CONTRACT CHANGE ORDER NO. 186
SHEET 2 OF 14

SAN FRANCISCO OAKLAND BAY BRIDGE
EAST SPAN SEISMIC SAFETY PROJECT
SELF-ANCHORED SUSPENSION BRIDGE
(SUPERSTRUCTURE & TOWER)

BIKEPATH FRAMING DETAILS NO. 2

BIKEPATH DETAILS NO. 4

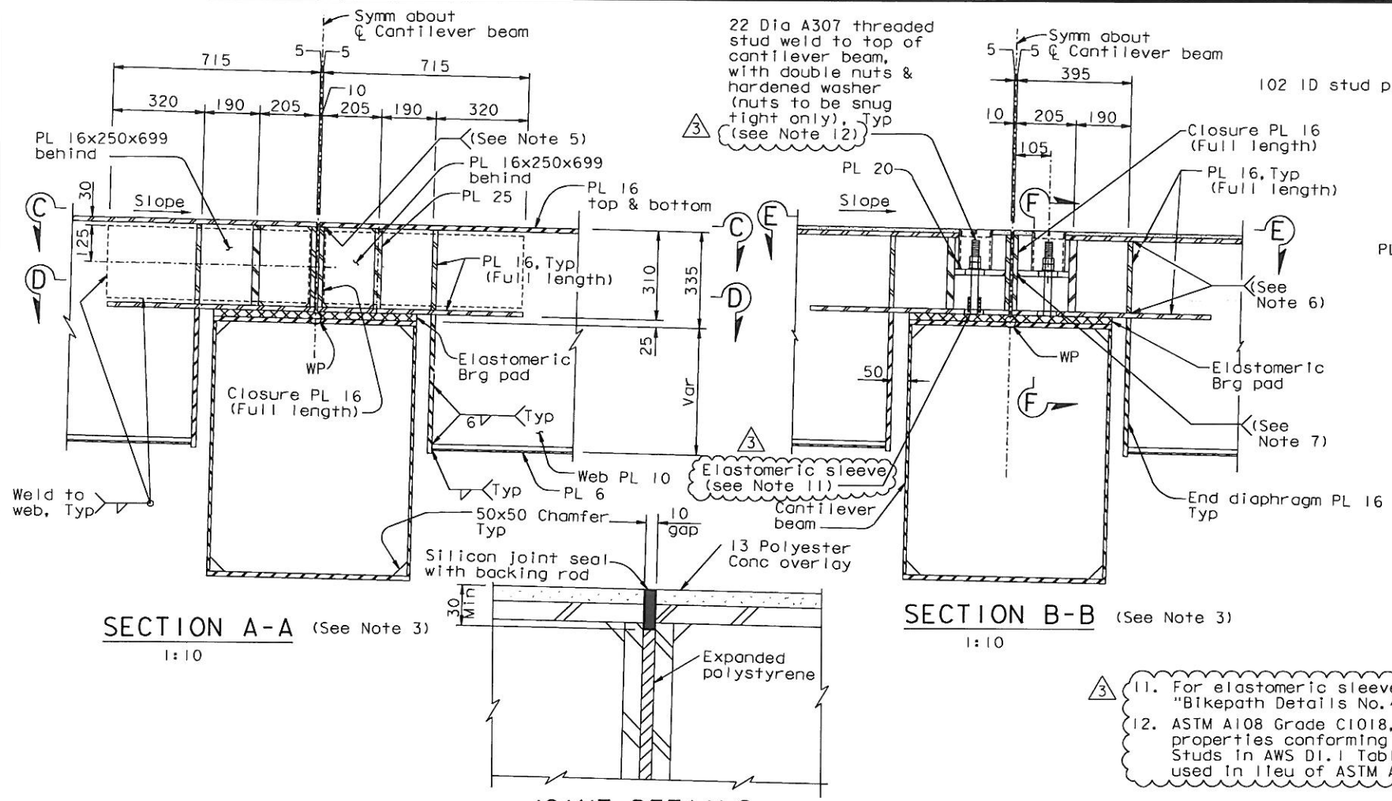
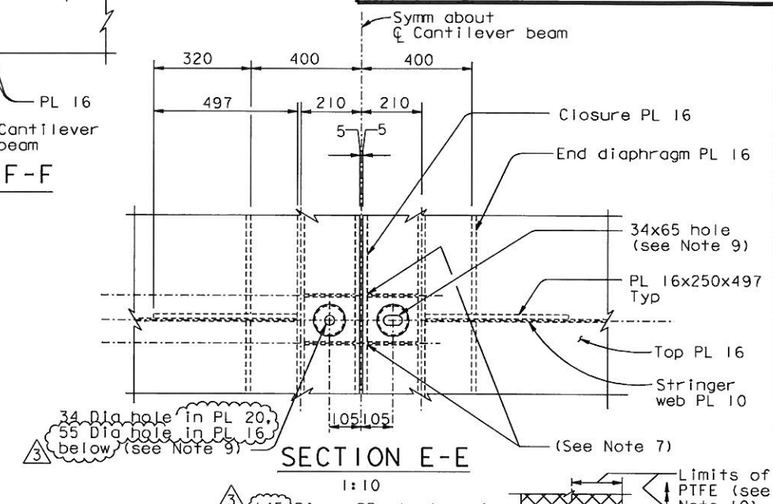
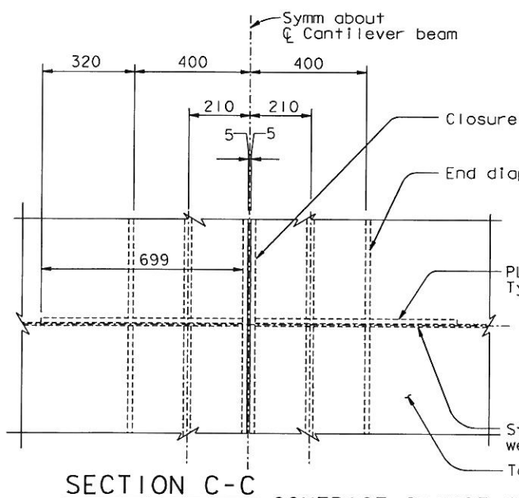
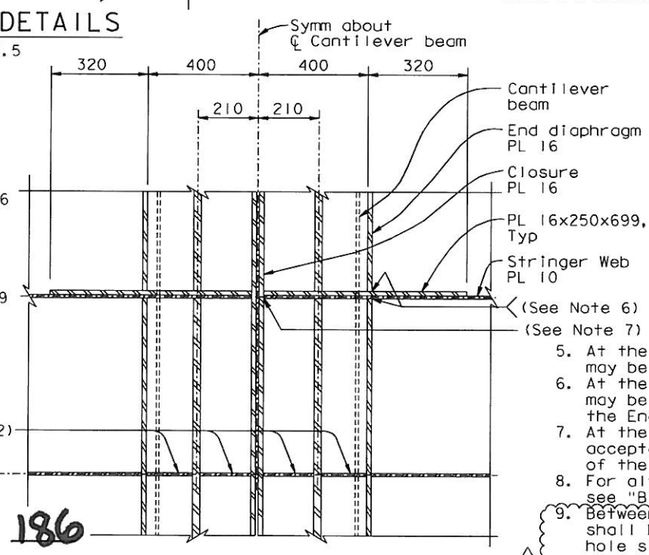
MARK	DATE	DESCRIPTIONS	BY	CH'D	CCO#
3	02/04/11	BIKEPATH STUD ISSUE	CC	TH	186
2	08/20/10	BIKEPATH DETAILS	CC	TH	99
1	07/24/09	BIKEPATH DETAILS	CC	TH	99

10. For PTFE details, see Section A-A on "Bikepath Details No.1" sheet.
11. For elastomeric sleeve detail, see "Bikepath Details No.4A" sheet.
12. ASTM A108 Grade C1018, with mechanical properties conforming to that of Type B Studs in AWS D1.1 Table 7.1, may be used in lieu of ASTM A307.

BIKEPATH DETAILS NO. 4A

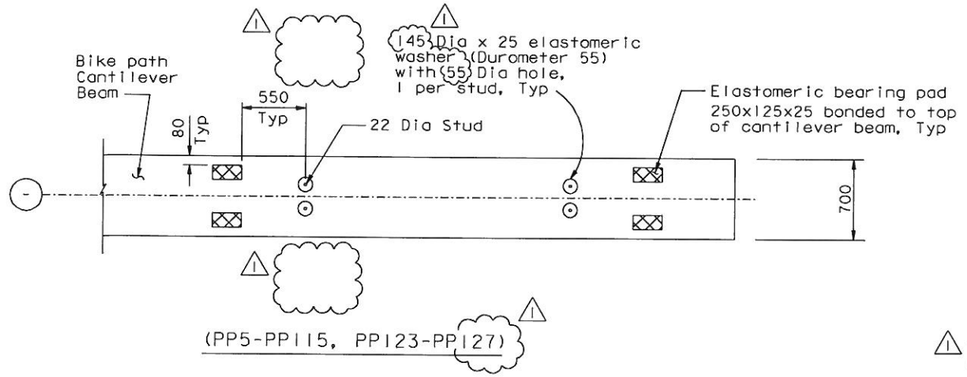
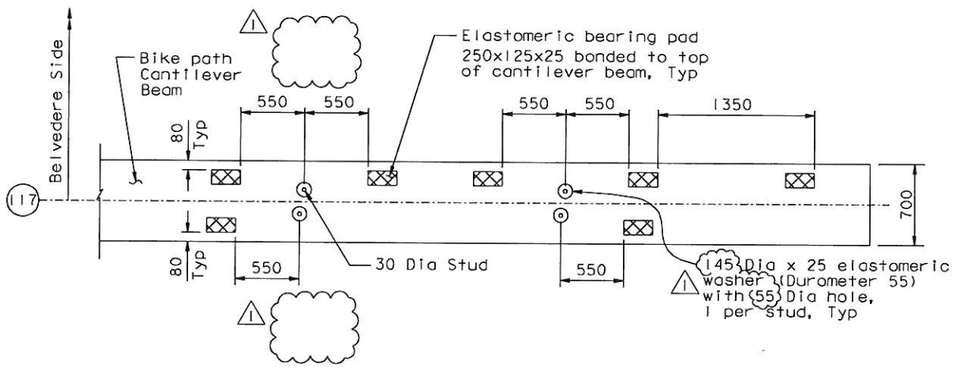
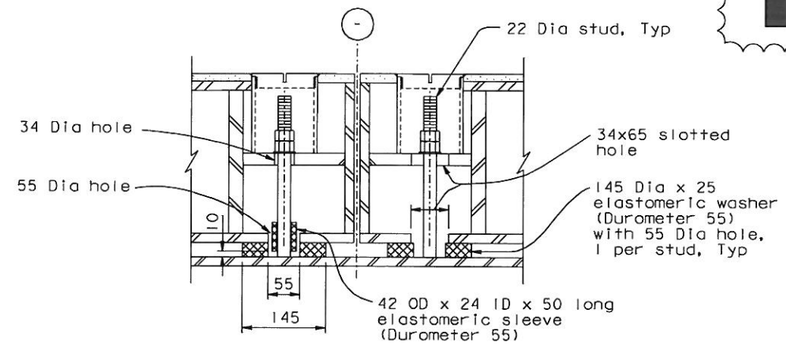
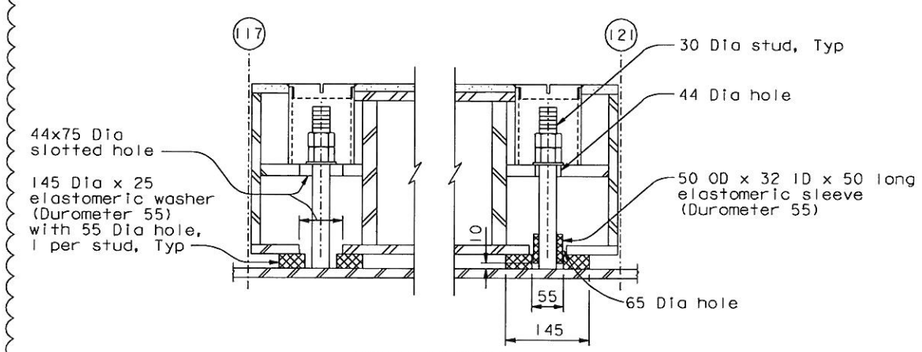
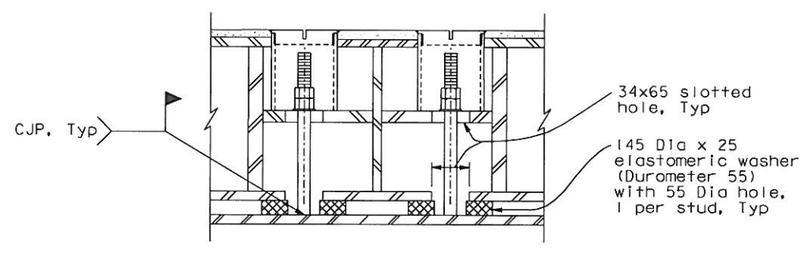
MARK	DATE	DESCRIPTIONS	BY	CH'D	CCO#
1	01/25/11	BIKEPATH STUD ISSUE	TH	CC	186
0	08/20/10	BIKEPATH DETAILS	CC	TH	99

BIKEPATH DETAILS NO. 17

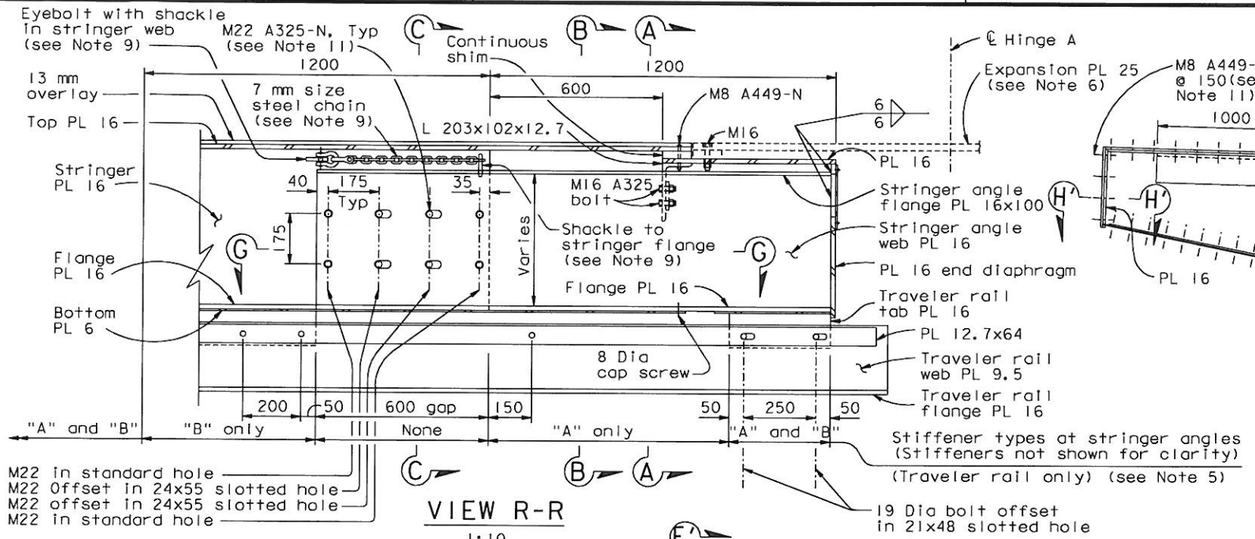
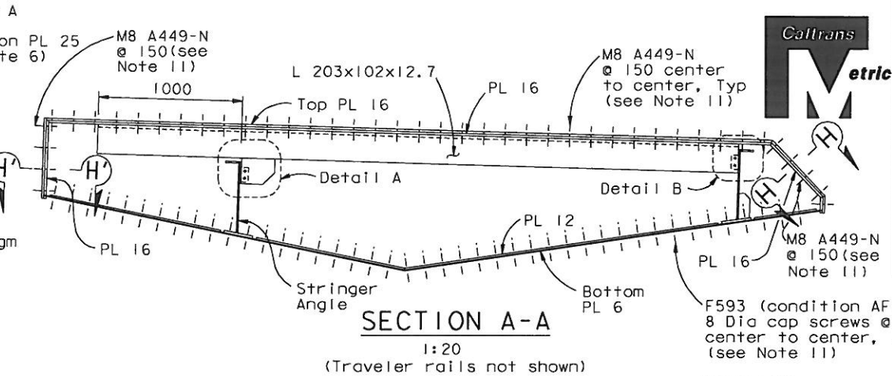
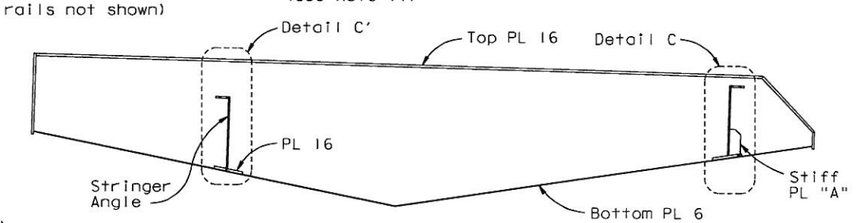
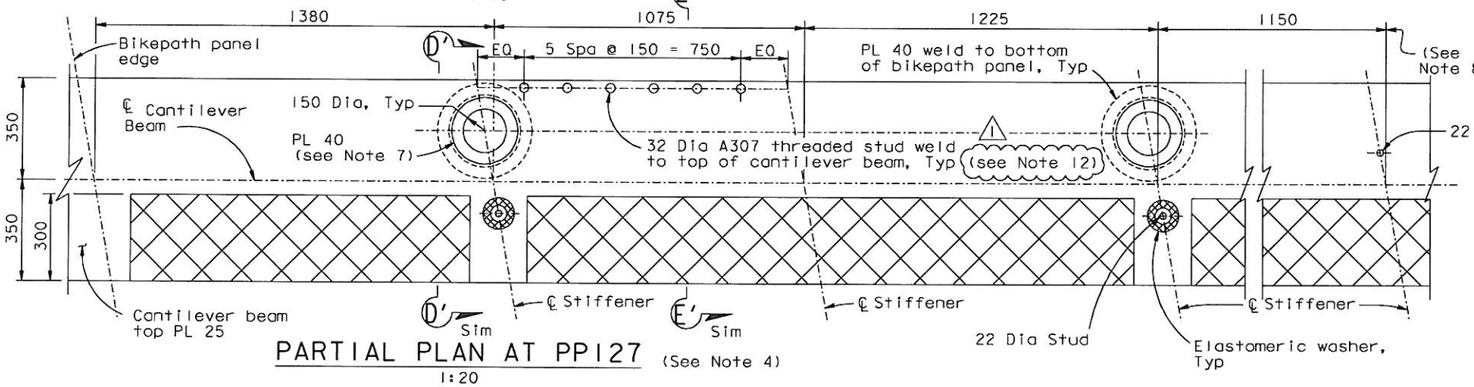
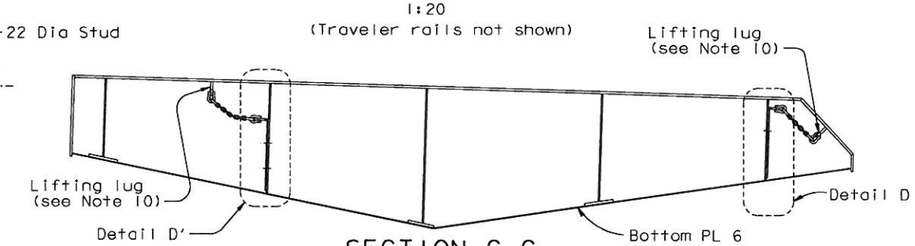
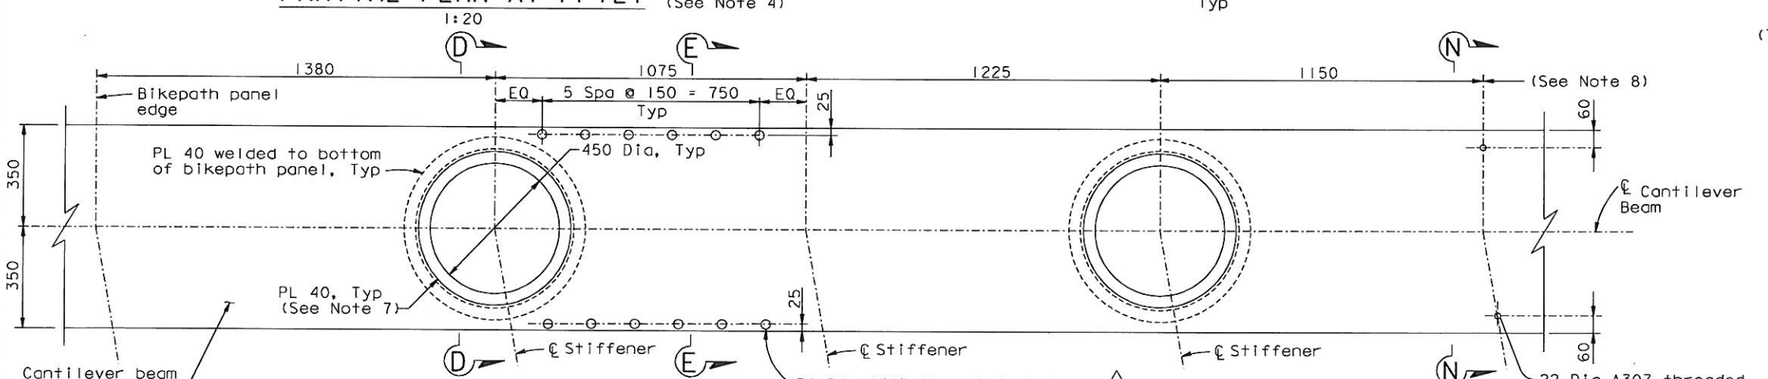
12. ASTM A108 Grade C1018, with mechanical properties conforming to that of Type B Studs in AWS D1.1 Table 7.1, may be used in lieu of ASTM A307.

MARK	DATE	DESCRIPTIONS	BY	CH'D	CCO#
1	02/04/11	BIKEPATH STUD ISSUE	CC	MN	186
0	08/20/10	BIKEPATH DETAILS	RB	MN	99
